County of San Diego Department of Planning and Land Use BUILDING DIVISION

ACCESSIBILITY CORRECTION LIST

Multifamily Housing

Doors and Gates

CBC FIGURE 11A-8A - FRONT APPROACH TO HINGED DOOR

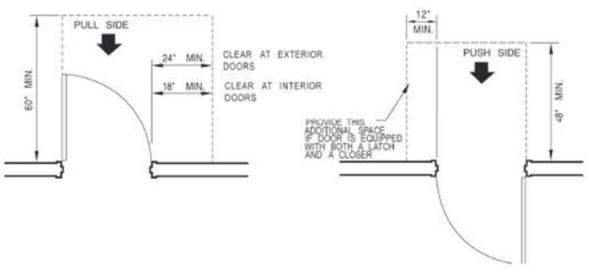
GENERAL REQUIREMENTS		7.	Dimension clear and level landings per CBC Figure 11A-8A for each hinged door requiring front approach:
1.	Provide door/gate schedule coordinated with floor plans and indicating the following for each door and gate: Operation type (e.g., hinged, sliding, pocket, folding, automatic, power-assisted, delayed-egress) Nominal and clear width Height Opening hardware Latch (if provided) Closer (if provided)		□ Front approach to pull side of door: ○ Width: Door width plus minimum 24 inches beyond latch side of exterior door and minimum 18 inches beyond latch side of interior door ○ Depth: Minimum 60 inches perpendicular to doorway □ Front approach to push side of door with latch and closer: ○ Width: Door width plus minimum 12 inches beyond latch side of door ○ Depth: Minimum 48 inches perpendicular to doorway □ Front approach to push side of door without latch/closer

CBC FIGURE 11A-8D - FRONT APPROACH TO SLIDING/FOLDING DOOR

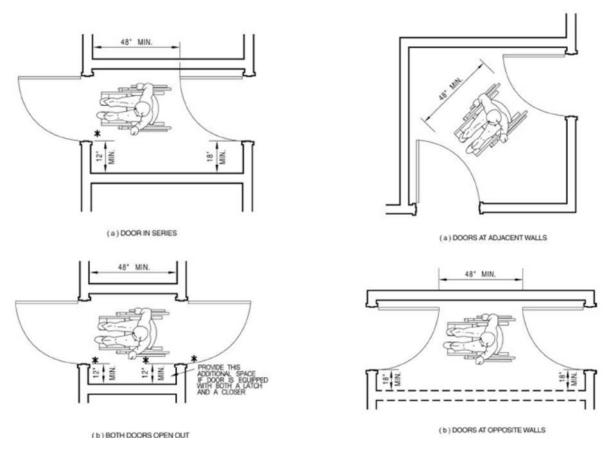
- 10. Dimension clear and level landings for each sliding or folding door:Front approach per CBC Figure 11A-8D:
 - Width: Door width
 - Depth: Minimum 48 inches perpendicular to doorway
 Slide-slide approach:
 - Width: Minimum 54 inches measured from latch side of door toward slide side
 - Length: Minimum 48 inches perpendicular to doorway Latch-side approach:
 - Latch-side approach:Width: Door width plus minimum 24 inches beyond latch
 - Width: Door width plus minimum 24 inches beyond latch side of door
 - Length: Minimum 44 inches perpendicular to doorway
 CBC 1126A.3.1
- For consecutive doors in a vestibule, dimension minimum 48-inch clearance between 90-degree door-opening positions per CBC Figure 11A-8G and CBC Figure 11A-8H.
